Appendix K: Public Comment Responses

**Supplemental Environmental Impact Statement/
Overseas Environmental Impact Statement
Mariana Islands Training and Testing**

This appendix includes public comments on the Mariana Islands Training and Testing (MITT) Draft Supplemental Environmental Impact Statement/Overseas Environmental Impact Statement (SEIS/OEIS) and the Navy's responses to those comments.

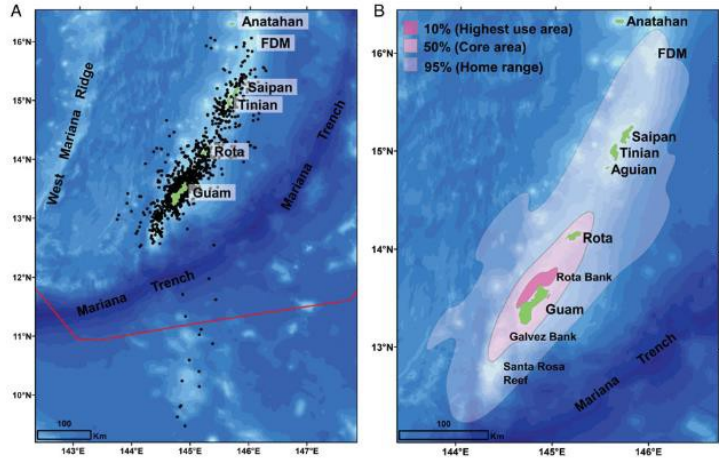
NRDC-06	<p>b. Chalan Kanoa Reef Geographic Mitigation Area</p> <p>The Chalan Kanoa Reef is intended to provide year-round protection for marine mammals from in-water explosives and a seasonal (December-April) reporting requirement for MF1 surface- ship hull-mounted mid-frequency active sonar used in this area is required due to aggregations of breeding humpback whales. Other species afforded protection by the prohibition on explosives include spinner dolphins, bottlenose dolphins, short-finned pilot whales, false killer whales, rough-toothed dolphins, and pygmy killer whales, all of which have been documented at Chalan Kanoa Reef (DEIS at Appendix I-16-I-17).</p> <p>The boundaries of the proposed Chalan Kanoa Reef Geographic Mitigation Area are defined by a simple polygon encompassing exposed fringing reef, reef flats exposed at low tide, nearshore shallow waters (less than 20 meters in depth), and a portion of Saipan Harbor (DEIS at Appendix I-13). The relative concentration of total marine mammal sightings and tag detections as observed and documented between 2007 and 2018, which include seasonal (February-March) humpback</p>	<p>As with the Marpi Reef Mitigation Area, the Navy considered using bathymetry to define the Chalan Kanoa Reef Mitigation Area, but instead relied on confirmed sightings of marine mammals and sea turtles to define the area. Using the recommendation in the comment and after reviewing the cited reference presenting bathymetry of the reef and surrounding areas, coupled with the ephemeral nature of marine mammal sightings, the Navy has reevaluated how the Chalan Kanoa Reef Mitigation Area is defined and has redefined the spatial extent of the area based on the 400 m isobath. Humpback whale sightings seaward of the forereef helped to identify the seaward extent of the area of potential biological importance. Sightings of humpback whales, other cetacean, and sea turtles along the fore reef and closer to shore than the offshore humpback sightings suggested that these areas may be of greater importance to multiple species, including humpbacks, than the areas farther from shore. Deeper areas beyond the reef are not necessarily areas of potential biological importance (i.e., humpbacks in these areas may have been transiting to or from the shallower areas closer to the reef when sighted). In addition, during a review of the Chalan Kanoa Reef sightings and bathymetry, the Navy found that the mitigation graphics in Appendix I (Geographic Mitigation Assessment) had errors where bathymetric lines plotted were incorrectly shifted. This issue was fixed on using a more accurate small-scale bathymetric dataset. Revised figures for the Final Supplemental EIS/OEIS show that most humpback whale sightings near Chalan Kanoa Reef where suspected reproductive behaviors were observed (mother-calf pairs, competitive behavior)</p>

Comment	Navy Response
	<p>whale sightings documented during non-systematic small-boat surveys occurring from 2015 through March 2018. Id. As with Marpi Reef, defining the Geographic Mitigation Area based solely on survey sightings may overlook other important habitat in the immediate vicinity that shares the same characteristics and biological function.</p> <p>In addition, vessel speed restrictions and a prohibition on low-frequency sonar should be observed during the humpback whale breeding season. Given the observed presence of particularly noise-sensitive species at Chalan Kanoa Reef (e.g., false killer whales), the Navy should also impose a year-round prohibition on air-deployed mid-frequency active sonar within the Geographic Mitigation Area.</p> <p>We therefore make the following recommendations with respect to this area:</p> <p><i>1. Extend the Chalan Kanoa Reef Geographic Mitigation Area boundaries to encompass the entire reef as defined by the 200 m depth contour.</i></p> <p>In defining the boundaries of the Chalan Kanoa Reef Geographic Mitigation Area, we recommend that the Navy include the entirety of Chalan Kanoa Reef as defined by the 200 m depth contour (i.e., the Mitigation Area should be extended to the west and south to encompass the entire reef habitat).</p>	<p>were shallower than the 200 m isobath. There were two mother-calf pair sightings outside of the 200 m isobath, but shallower than the 400 m isobath. Therefore, the Navy revised the Chalan Kanoa Reef boundaries to encompass the 400 m isobath on the northern, western, and parts of the southern boundaries, shown in Appendix I, Figure I-3, which encompasses most sightings. As described in Appendix I (Geographic Mitigation Assessment), the Navy developed new mitigation for the Final Supplemental EIS/OEIS to include a restriction on the number of hours of surface ship hull-mounted MF1 mid-frequency active sonar used from December 1 to April 30 within the Marpi Reef Mitigation Area and Chalan Kanoa Reef Mitigation Area.</p>
